**ADDENDUM NO. 5**  
**to**  
**PLANS and SPECIFICATIONS**  
**for**

**Medina River Sewer Outfall, Segment 2**  
**SAWS Job No. 11-2503**

**Issue Date: December 8, 2010**

**DETAIL FOR  
FIBERGLASS PIPE REDUCER**  
N.T.S.

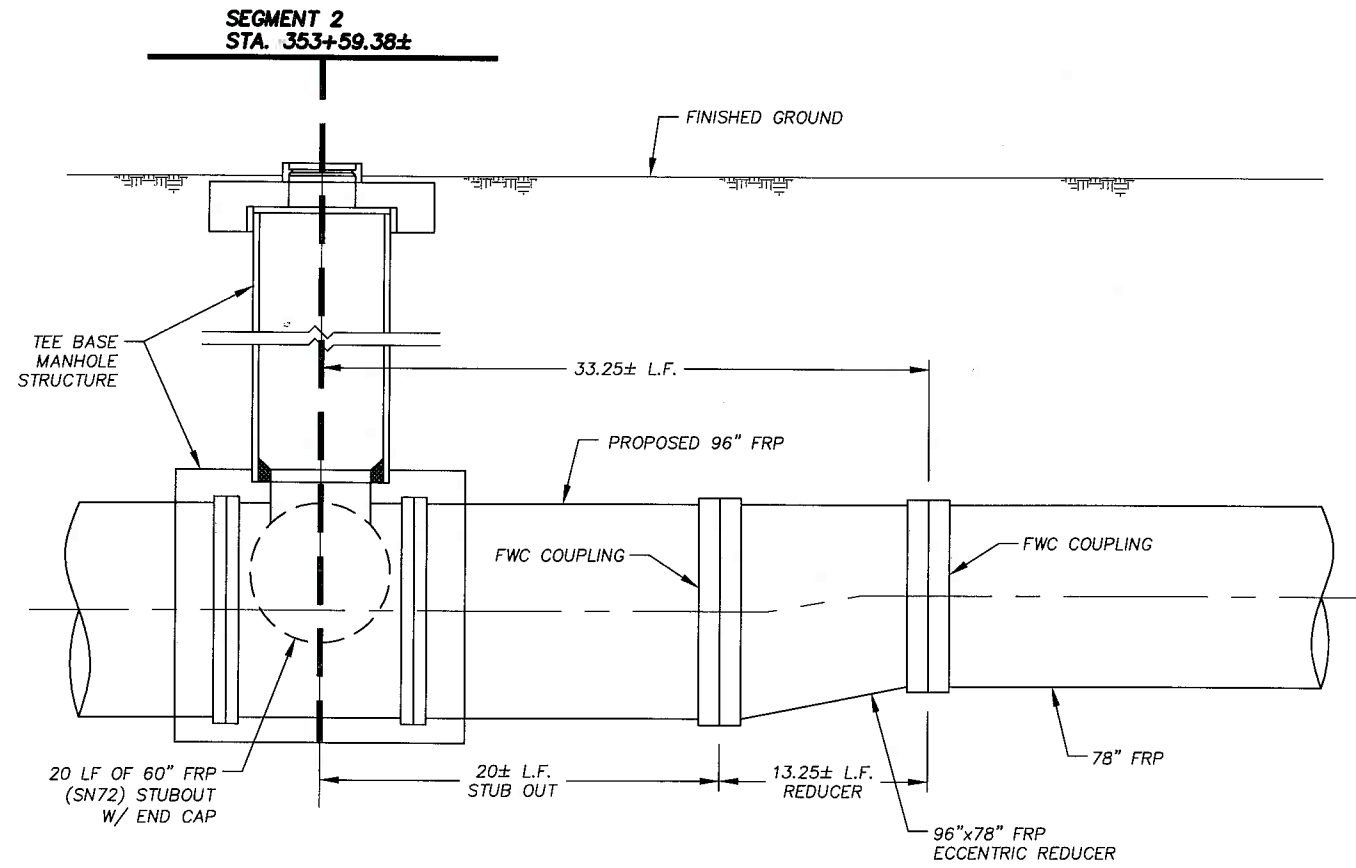
- A. Drawing No. D-02A, Sheet No. 42A – Include the attached sheet with the plan set. This sheet to be referenced when installing the 96-inch Tee Base manhole at Sta. 353+59.38.
